NL-28 Upgrade Request

This is an announcement regarding our standard sound level meter, NL-28.

Ref. No.: 2024-066-E

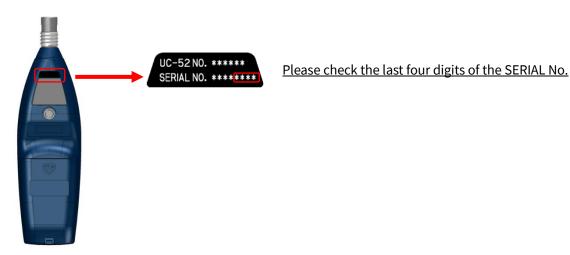
We have come to the realization that there may be a problem with the meter, and would like to ask for your cooperation in updating the firmware for any units of the NL-28 currently in use.

Depending on the timing of turning off the power or removing the batteries, the power may not turn on the next time the device is started, or the correct measurement value may not be displayed.

Due to a firmware malfunction, it was found that in rare cases the time it takes to access the internal memory may be longer. If the power is turned off or the battery is removed during this time, the data in the internal memory may be corrupted, causing a malfunction.

The malfunction can be resolved by updating to the latest firmware.

You can download the latest firmware from our website and upgrade it yourself. Please check our website for details.
